Access Compliance Report

Public Rights-of-Way

Intersection ID: 14359	Main Street: N_COLONIAL_AV	Cross Street: VAIL_AV	Location: S
ADA ID: 7337DD12DC34	Ramp Type: PerpDiag	Initial Pass/Fail: Fail	Overall Compliance: No
		Severity Score: 12.5

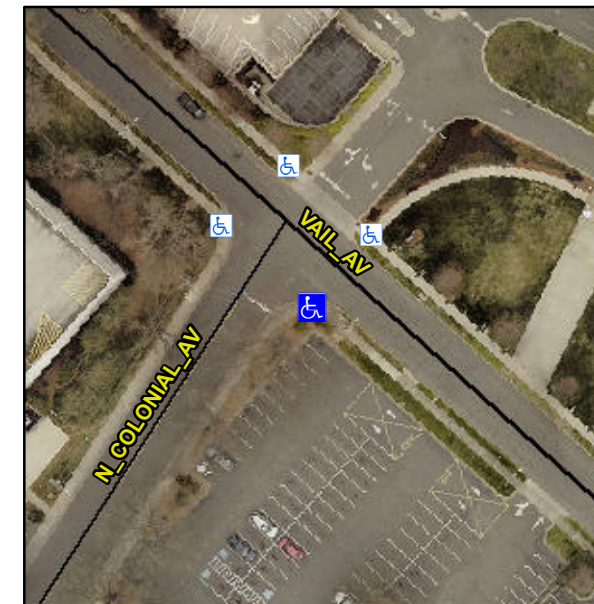
Not Found, R304.5.3

Compliance	Description	Data	Compliance	Description	Data
N/A	Ramp Length (in)	62.0	Yes	Ramp Slope (%)	5.5
Yes	Ramp Width (in)	58.0	No	Ramp XSlope (%)	5.8
N/A	Flare Type LT	N/A	N/A	Flare Type RT	N/A
N/A	Flare Slope LT (%)	N/A	N/A	Flare Slope RT (%)	N/A
N/A	Flare Traversable LT?	N/A	N/A	Flare Traversable RT?	N/A
N/A	Landing Length (in)	N/A	N/A	DWS Provided?	N/A
N/A	Landing Width (in)	N/A	N/A	DWS Contrast?	N/A
N/A	Landing Slope (%)	N/A	N/A	DWS Length (in)	N/A
N/A	Landing X Slope (%)	N/A	N/A	DWS Full Width?	N/A
N/A	Landing Curb? (Y/N)	N/A	N/A	DWS Offset (in)	N/A
N/A	Shared Landing?	N/A			
N/A	Gutter Ponding?	N/A	N/A	Gutter Slope (%)	N/A
N/A	Gutter Lip Ht (in)	N/A	N/A	Gutter X Slope (%)	N/A
N/A	Painted X Walk1?	No	N/A	Painted X Walk2?	No
	X Walk 1 Direction	To NE		X Walk 2 Direction	To NW
N/A	X Walk 1 Width (in)	N/A	N/A	X Walk 2 Width (in)	N/A
	X Walk 1 Slope (%)	5.9		X Walk 2 Slope (%)	5.3
	X Walk 1 X Slope (%)	3.8		X Walk 2 X Slope (%)	0.5

Remove & Replace Curb Ramp With Two New Directional Ramps or Equivalent.
